AGENDA
BUDGET & FINANCE COMMITTEE MEETING
Tuesday, September 14, 2021 at 7:00 p.m.
N168 W20733 Main Street
Jackson, WI 53037

SECTION 00 63 63
CHANGE ORDER

Change Order No. 10

NOT TO SCALE

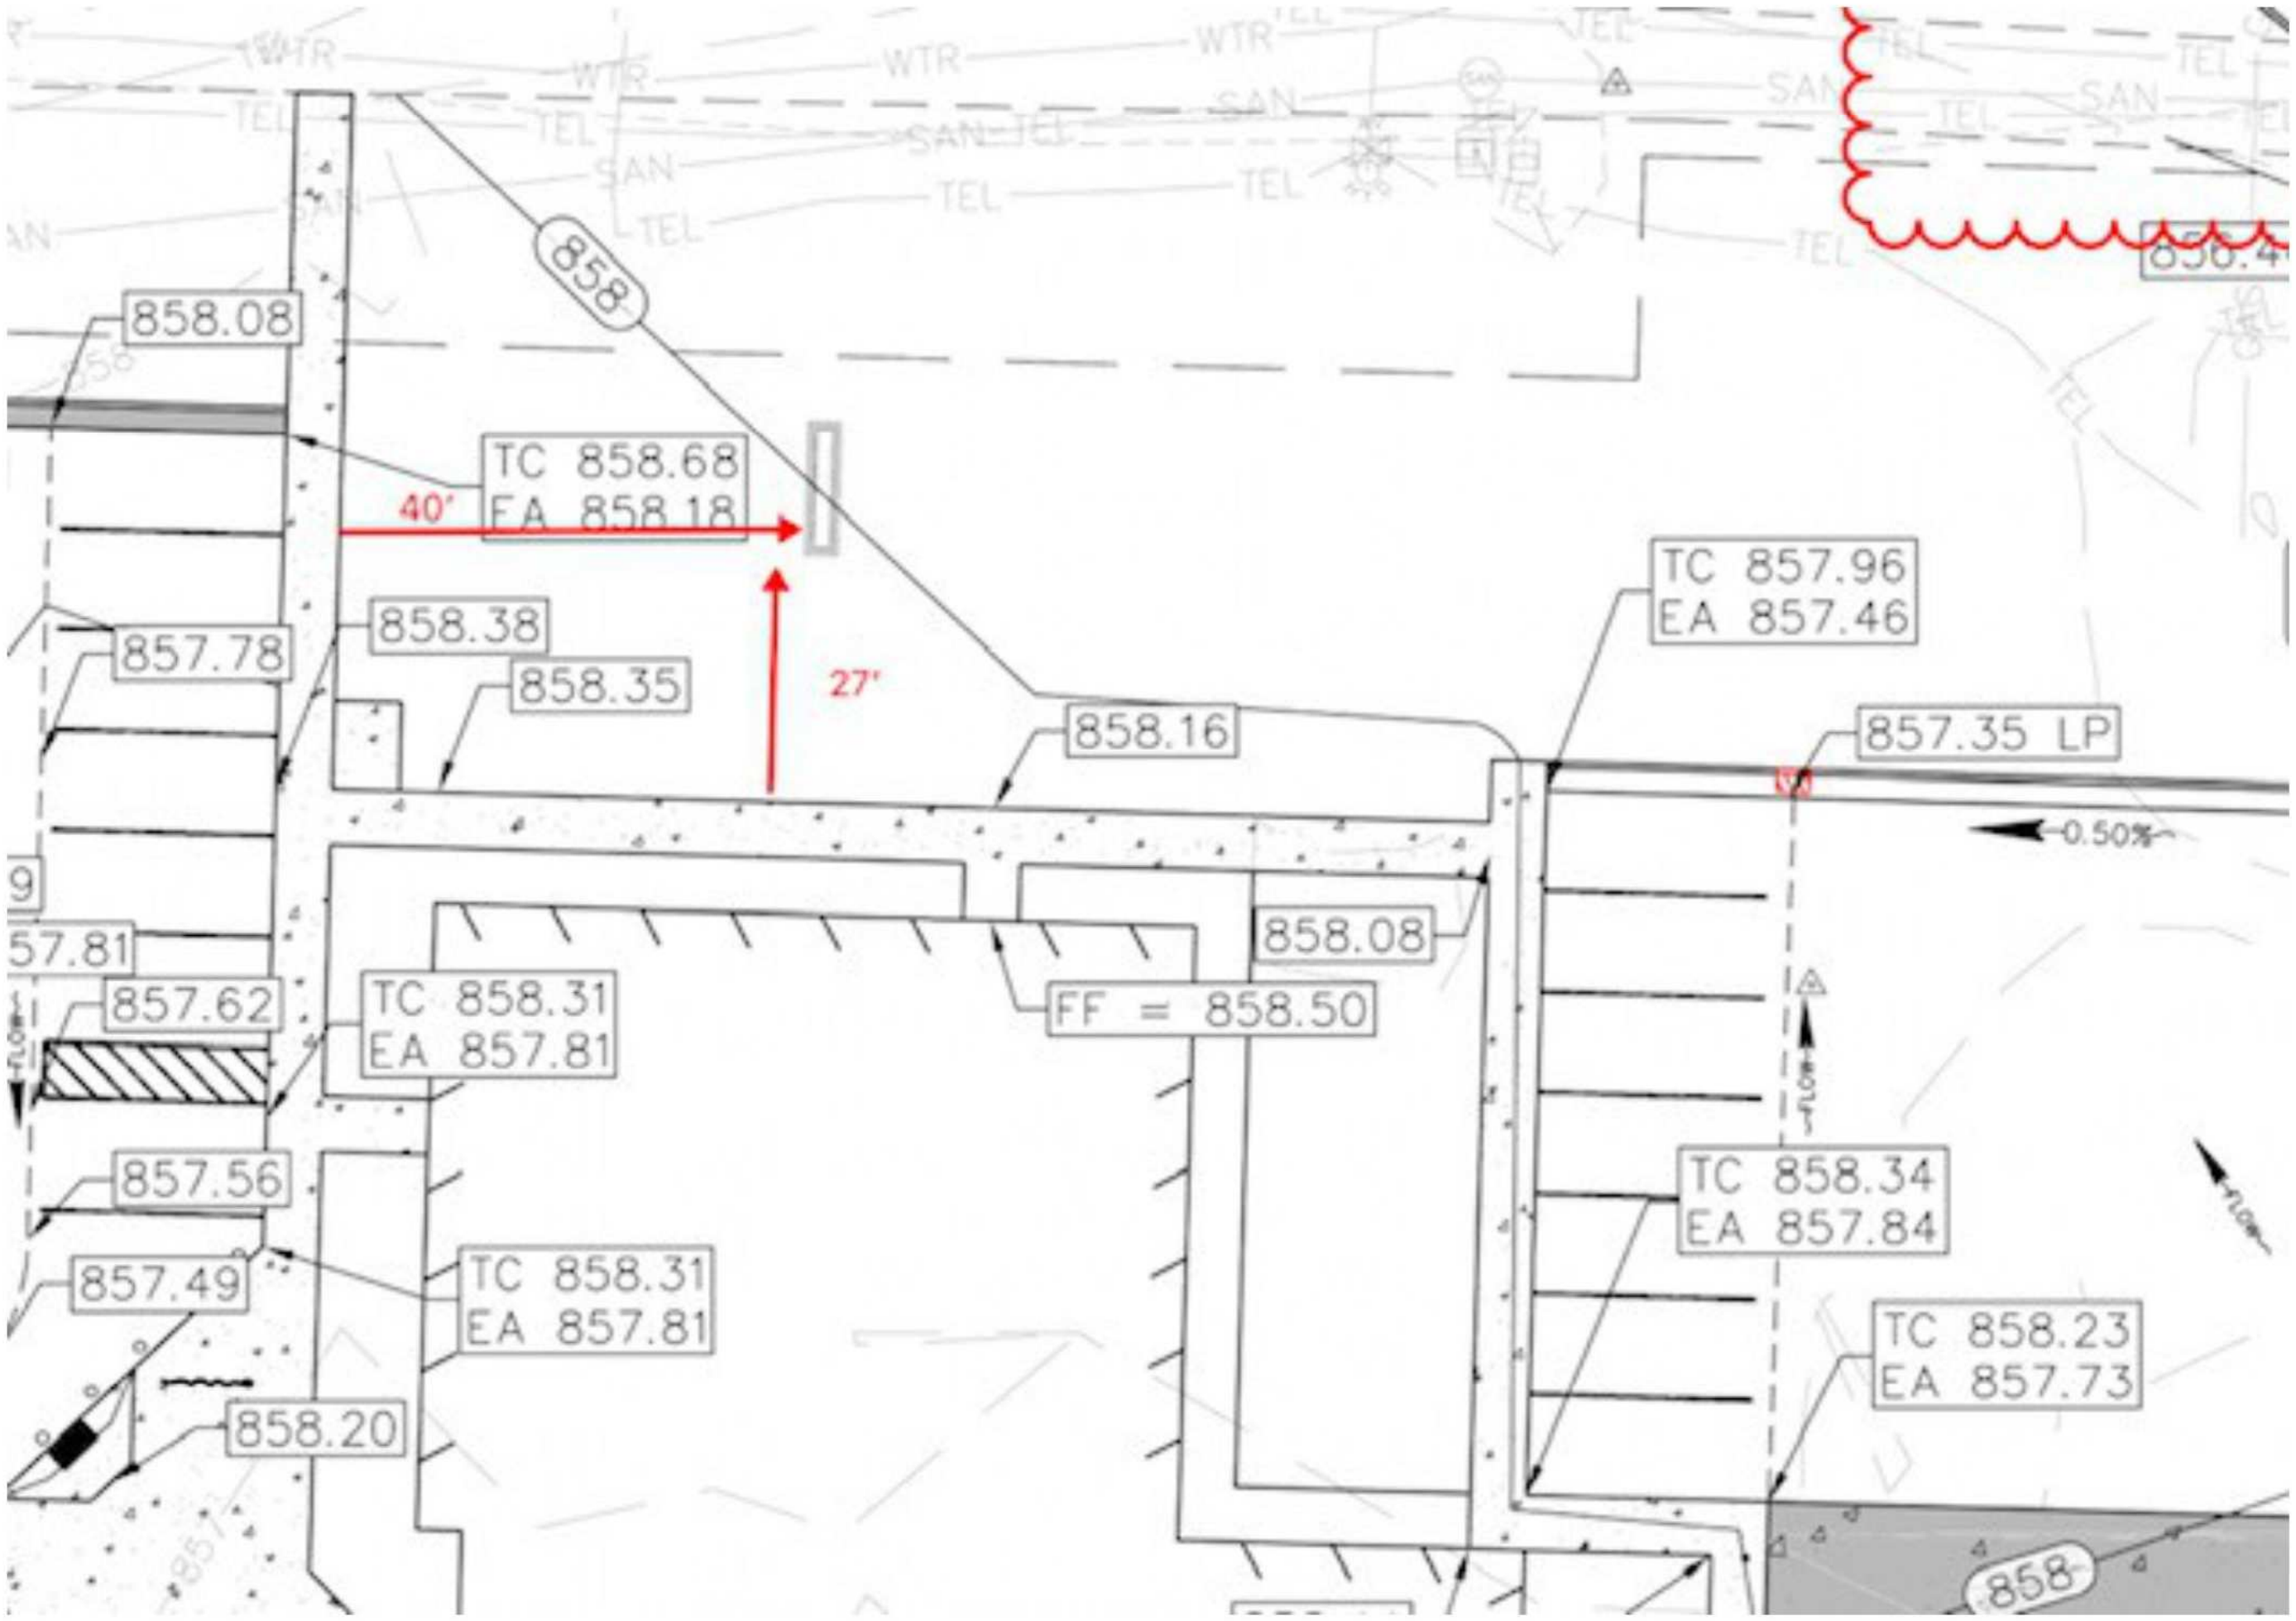
Addition of the furnishing and installation of circuit wiring and equipment components associated with the Owner provided Monument/Pylon signs. Work was initially removed from within the contract scope and then again added by the Owner upon finalizing the sign design and resolution.

Please provide a lump sum cost proposal related to the all-inclusive installation of electrical circuit wiring for the proposed Pylon Sign. Attached please find detailed information related to the scope of the work. Please base your proposal on this information.

15. RUN A 208/120 VOLT 1 PHASE 3 WIRE 60 AMP CIRCUIT IN THE EXISTING 1" CONDUIT TO THE PYLON SIGN PANEL. PROVIDE A 208/120 VOLT 1 PHASE 3 WIRE PYLON SIGN PANEL WITH (1) 120V 20A/1P BREAKER AND (1) 120V 40A/1P BREAKER LOCATED INSIDE PYLON SIGN. WIRE THE 20 AMP AND 40 AMP PYLON SIGN CONNECTIONS IN THE PANEL.

- Install electrical panel mounted in sign NEMA 1R
- Provide and install sign wiring
- Sign controls are wireless

SHEET NO.
E301AB

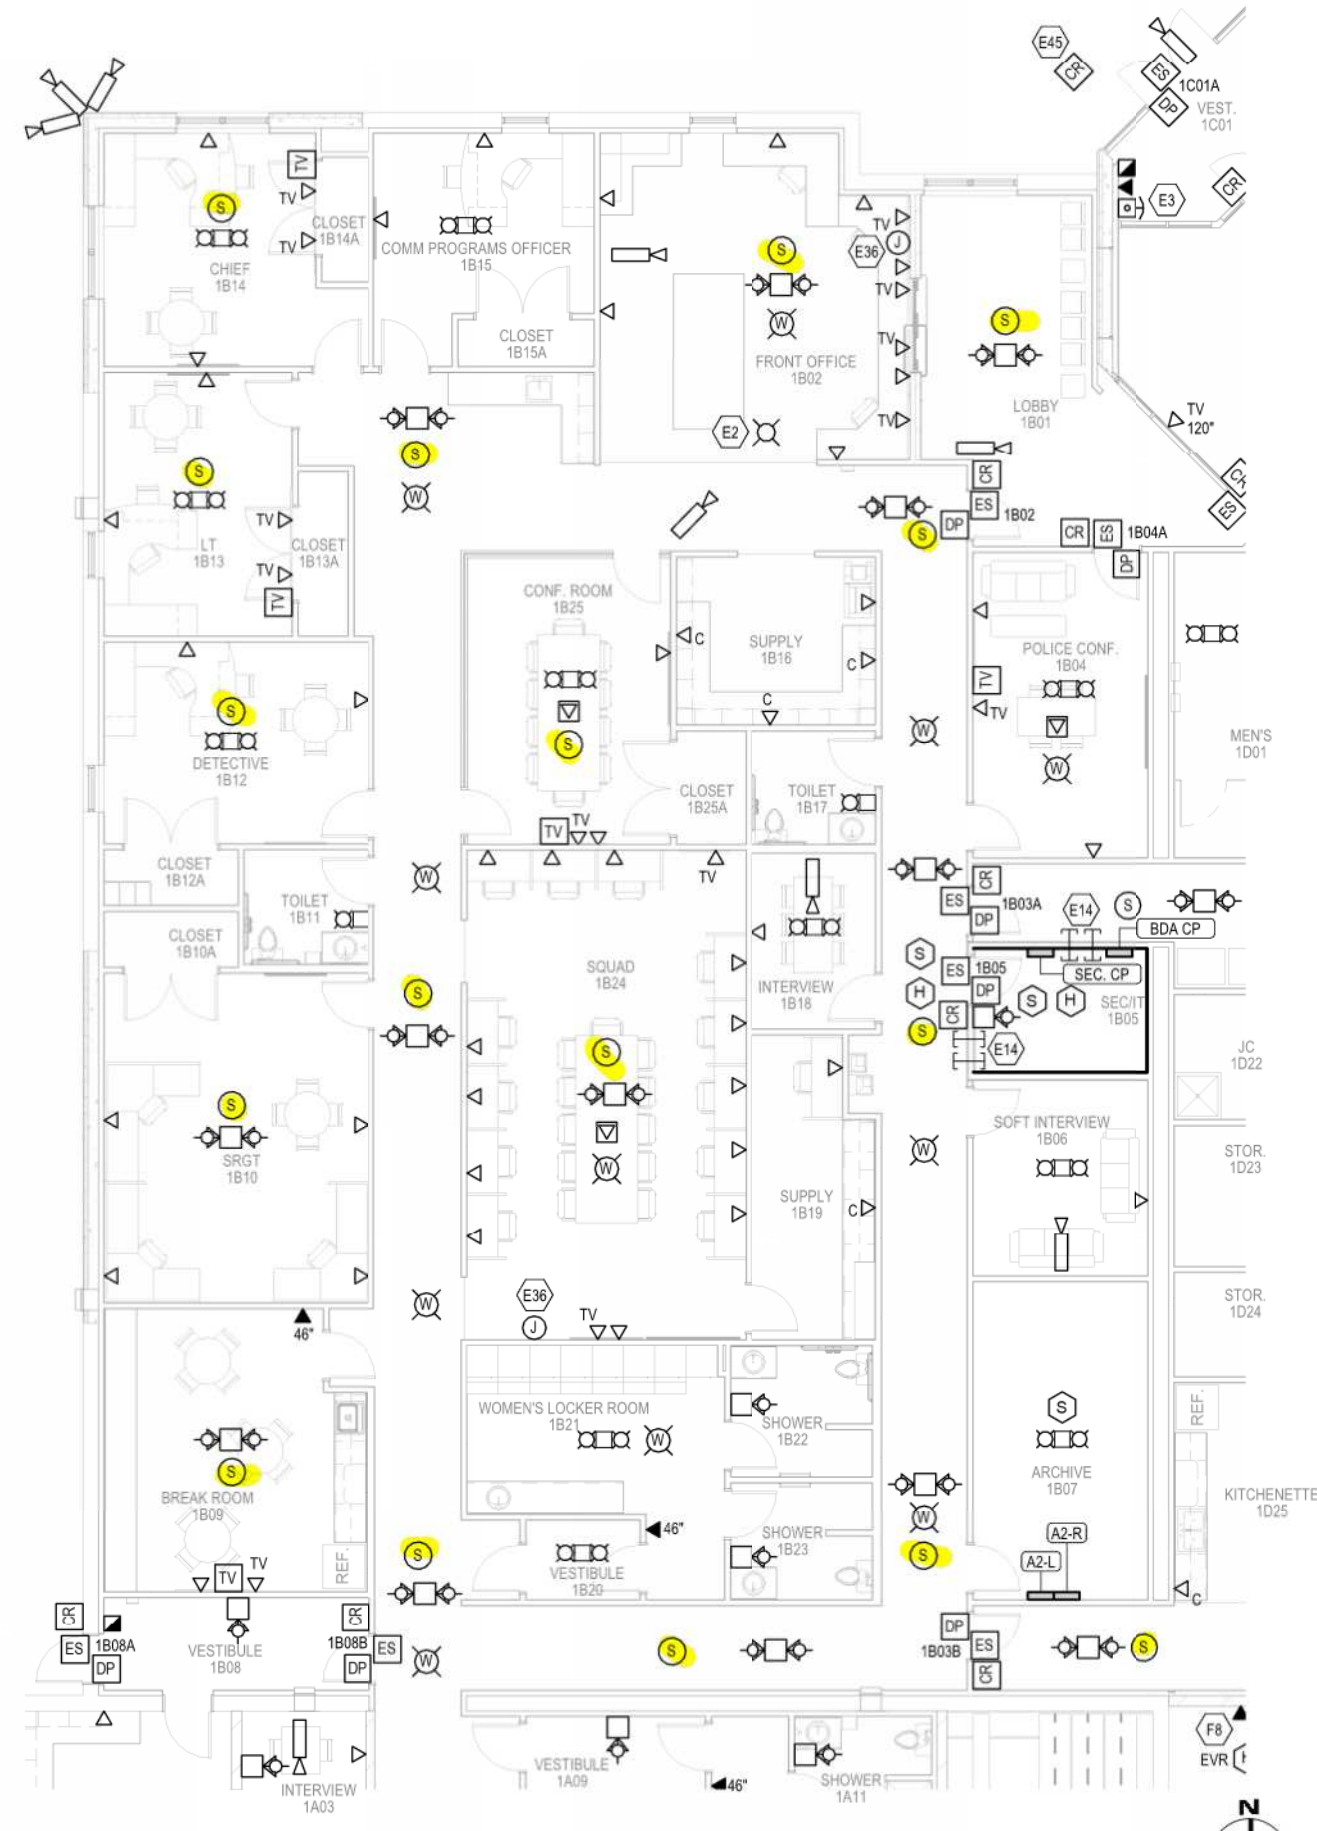
Revisions to speaker wire plan as revised by Owner's Audio Visual vendor (AVI) to accommodate system needs as prescribed by Owner; Revision to speaker cabling locations and addition of volume controls.

1) Revision Notes – Drawing Sheets E301AB, E301C, E301D, E301E, E302D & E302E
2) E-mail correspondence between A/E and Contractor dated 8/18/21 – 8/20/21
3) Contractor's Cost Proposal, PCO #72 dated 8/20/21 signed by Owner

- Provide within your proposal a line item considering the reduction in scope of work from the bid plan (3,000 ft of wire) to revised plan (1,400 ft of wire).
